# SAFETY RECALL BULLETIN

SUBJECT:			No: <b>SR-14-004</b>
<b>2014 LANCER EVOLUTION AND LANCER RALLIART POWER STEERING PRESSURE HOSE ASSEMBLY – SAFETY RECALL CAMPAIGN</b>			DATE: <b>June, 2014</b>
			MODEL: <b>2014 Lancer Evolution and Lancer Ralliart</b>
CIRCULATE TO:	<input checked="" type="checkbox"/> GENERAL MANAGER	<input checked="" type="checkbox"/> PARTS MANAGER	<input checked="" type="checkbox"/> TECHNICIAN
<input checked="" type="checkbox"/> SERVICE ADVISOR	<input checked="" type="checkbox"/> SERVICE MANAGER	<input checked="" type="checkbox"/> WARRANTY PROCESSOR	<input checked="" type="checkbox"/> SALES MANAGER

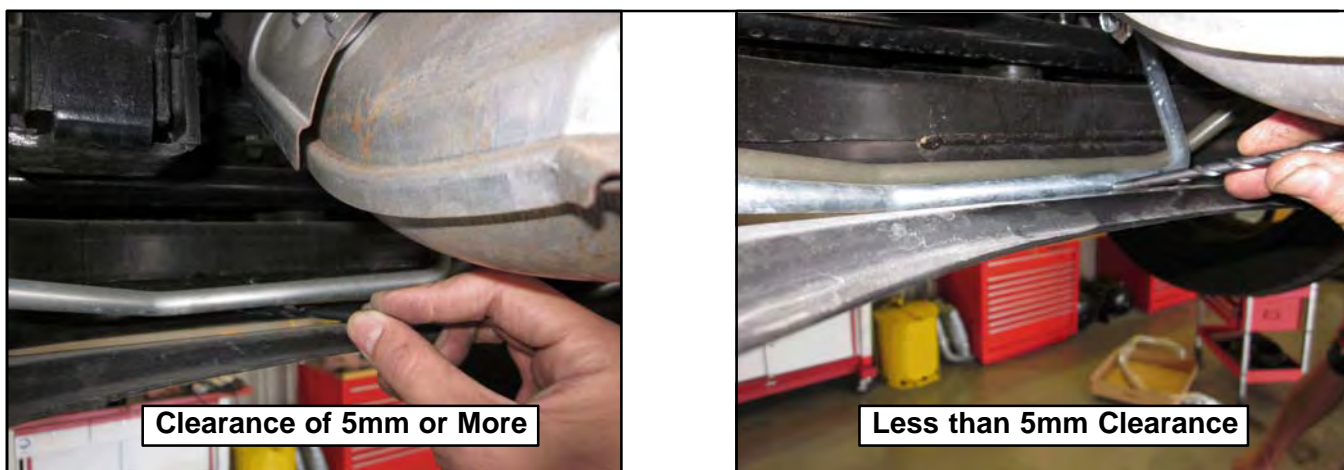
1. Place the vehicle on a lift. Set the parking brake and turn the ignition switch to "LOCK" (off) position. If vehicle is TC-SST equipped, ensure selector is in "P" (park) position.
2. Raise the vehicle. From underneath, locate the power steering pressure hose assembly and the crossmember brace (where the front exhaust pipe connects to the catalytic converter).

3. Using a taper gauge, thickness gauge, or 5mm drill bit, measure the clearance between the power steering pressure hose assembly and the crossmember brace.

- a. If the clearance between the two components is 5mm (0.2 in) or more, **replacement is not necessary**. Complete the campaign claim and enter campaign labor operation **C1404W01**.
- b. If the clearance between the two components is less than 5mm (0.2 in), proceed to the **Replacement Procedure** below.
